REFERENCE: B071-22 Lift Station for River Woods Subdivision and Surrounding Areas

Project Addendum No.1

ADDENDUM No. 1

DESIGN REVISIONS

TYPICAL RACK SUPPORT & ROOFING DETAIL

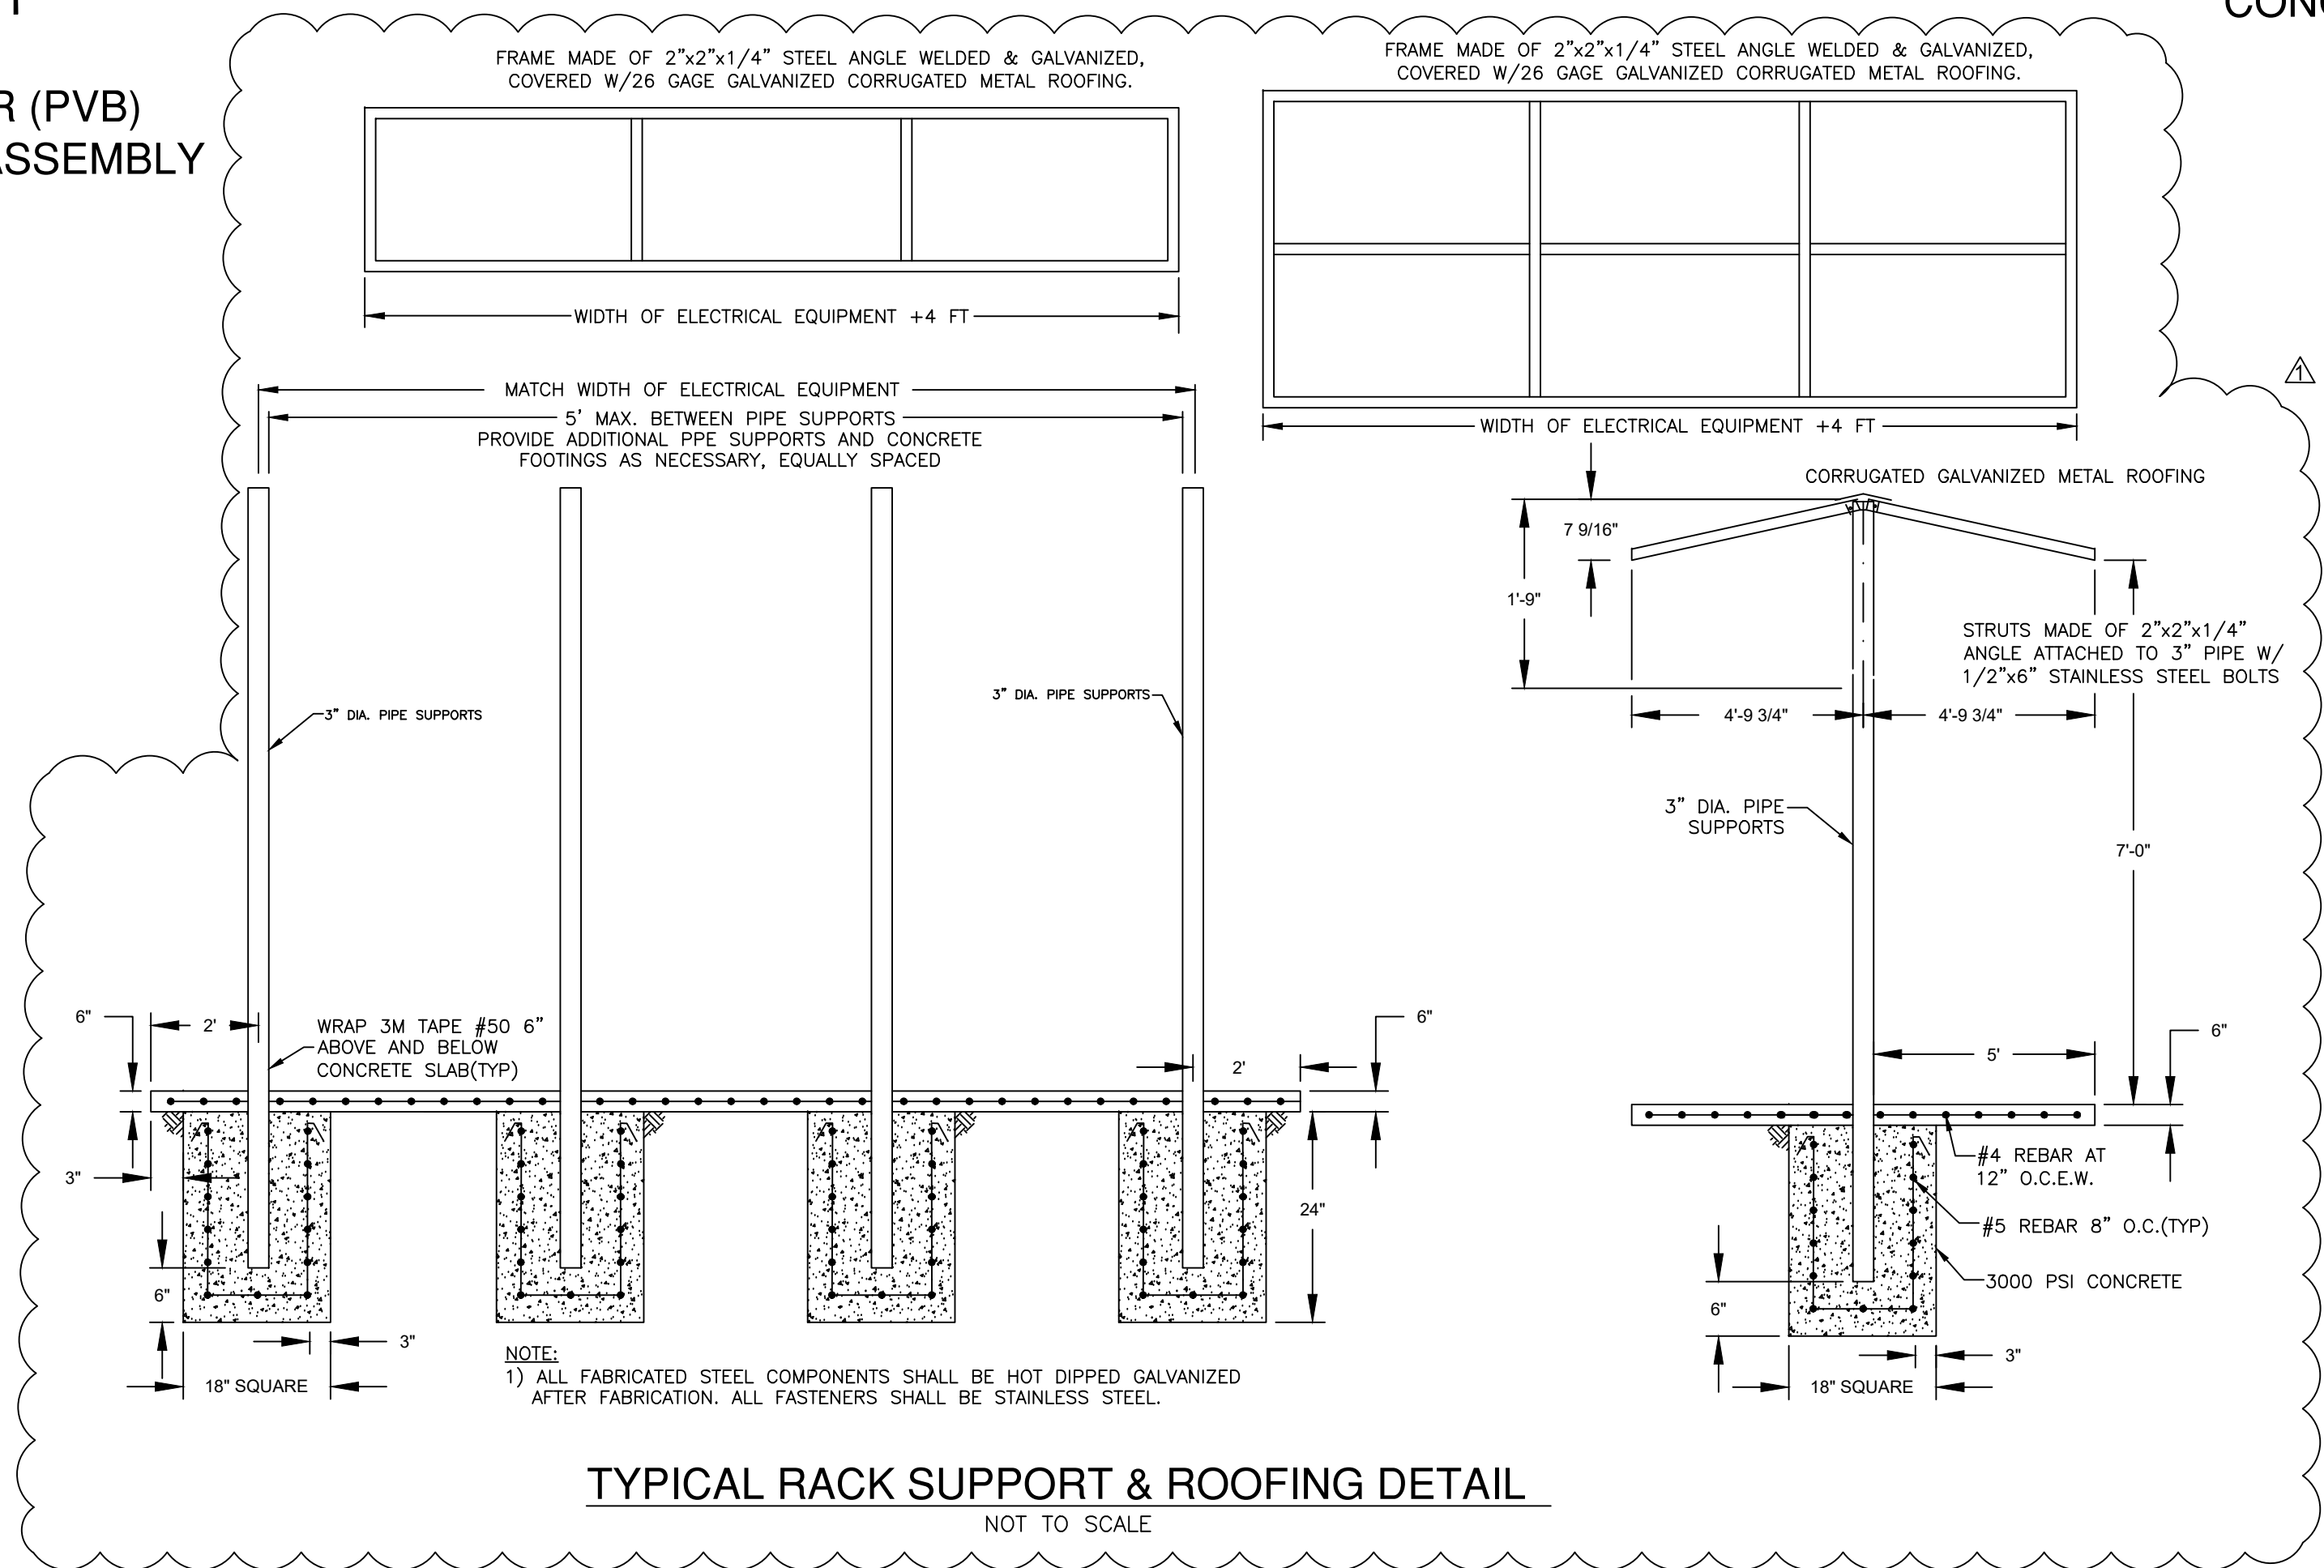
1. Sheet 8 – Structural delegated design note on sheet E4.00 has been replaced by the detail labeled “Typical Rack Support & Roofing Detail” for the proposed electrical equipment rack & canopy.
